**CDM: Response form for request for clarification on
Approved Methodologies
(version 01.1)**

<i>Date of Meth Panel meeting:</i>	25 - 29 October 2010
<i>Title and number of request for clarification</i>	Clarification request on the use of heat recovery steam generators to deliver steam to existing steam turbine generators for the generation of electricity from recovered heat. AM_CLA_0193

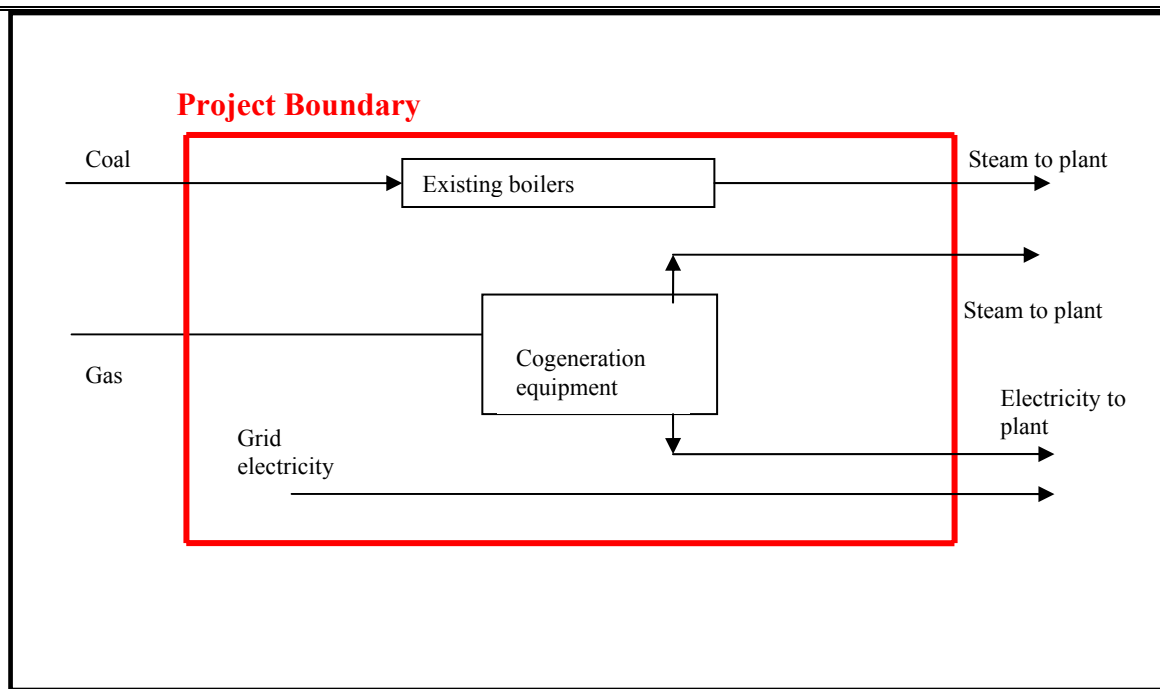
The project situation is described by PPs in the request and the attached PDD. The project is under validation and the DOE has requested that the PPs have to clarify whether the following situation comply with the applicability condition mentioned above.

Under the project activity the steam generated by heat recovery steam generator (HRSG) is fed to existing turbines to generate the 68MW in addition to the power produced by the same turbines on account of steam fed by existing coal-fired boilers.

- (1) The methodology does not require that the entire investment on the CDM project (cogeneration plant) should be new and therefore logically some components of existing plants can be used in the new project (fuel switching in an existing equipment is an explicitly acceptable project). The Meth Panel noted that the diagram presented in this methodology does not cover all possible alternatives described in the text. In cases where such a difference exists, project proponents are expected to follow the text of the methodology.

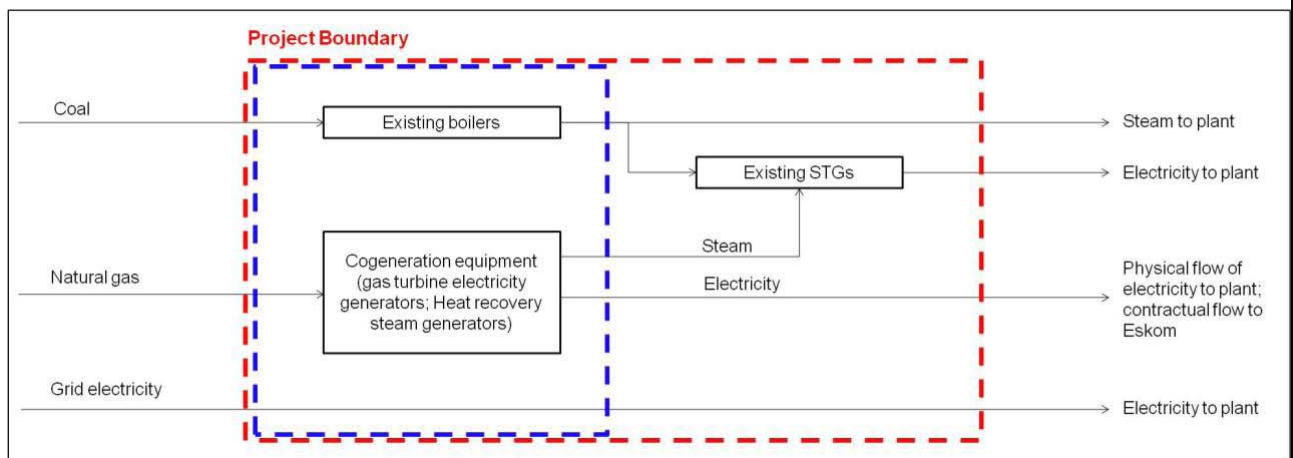
Also there is a mismatch in the project boundary. The following diagram indicates the project boundary given in the methodology.

Whereas from Figure 4 of the draft PDD (attached), the following project boundary is copied. The blue (inner) dashed line indicates that the project boundary of the project activity is identical to that in the methodology.

The remainder of the diagram (i.e. outside the blue border, but inside the red border) indicates the specific use of steam in the PP's project. The methodology does not specify what the steam from the project activity must be used for. The PDD for this project activity indicates the use of the steam for electricity production in existing equipment outside of the project boundary. This means that the baseline emissions for the steam can be calculated based on the electricity emissions factor from the grid (at ~1 t CO₂ / MWh). This is more conservative than if the baseline applied is the off-setting of steam generated in the PP's existing coal-fired boilers (at ~1.4 t CO₂ / MWh).

Whether this quantification method of the greenhouse gas emission reductions associated with the waste heat steam generation from the project activity is acceptable. The PP's view is that the methodology does allow for downstream description of the use of recovered waste heat in the case where that heat is used for the generation of additional electricity to further offset grid imports, otherwise the applicability criterion cannot be held to be true: "The methodology is applicable to project activities that install gas based energy generation (electricity and/or steam/heat) system..."

- (2) Based on the information provided in this request, the baseline emission factor of grid electricity that is offset by the additional electricity generated by recovering the waste heat is the appropriate value to be used since in the underlying project activity there is no substitution of the captive power produced in the baseline. Rather, there is an expansion of the capacity to replace the grid and in the absence of the project the grid would continue to provide the correspondent electricity.
